Amendments to the Drawings:

Attachments: Replacement Sheets 1 and 3
Annotated Sheets Showing Changes.

Fig. 2

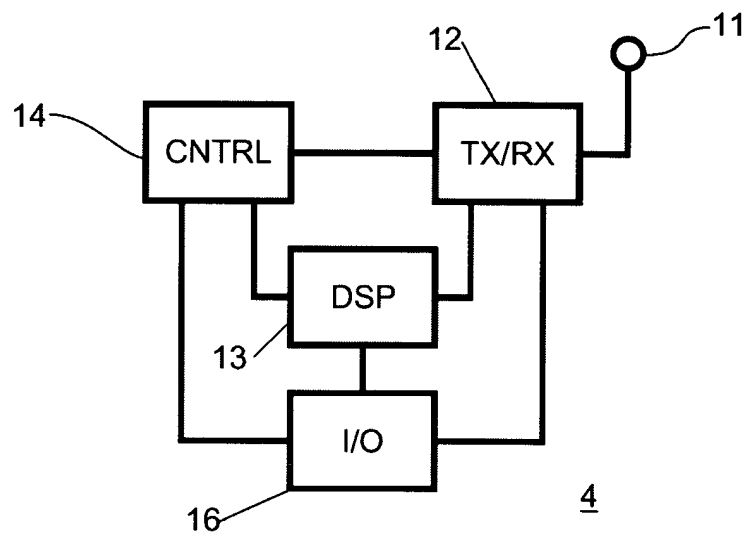
The attached drawing sheets, sheets number 1 and 3, includes changes to Figure 2 and Figure 7. Drawing sheet 1, which includes Figures 1-3, replaces the original sheet including Figures 1-3. In Figure 2, the reference number connected to the block containing "CNTRL" has been changed from "13" to "14". Drawing sheet 3, which includes Figures 6-7, replaces the original sheet including Figures 6-7. In Figure 7, a functional block indicating the DSP controller and a corresponding reference number have been added.
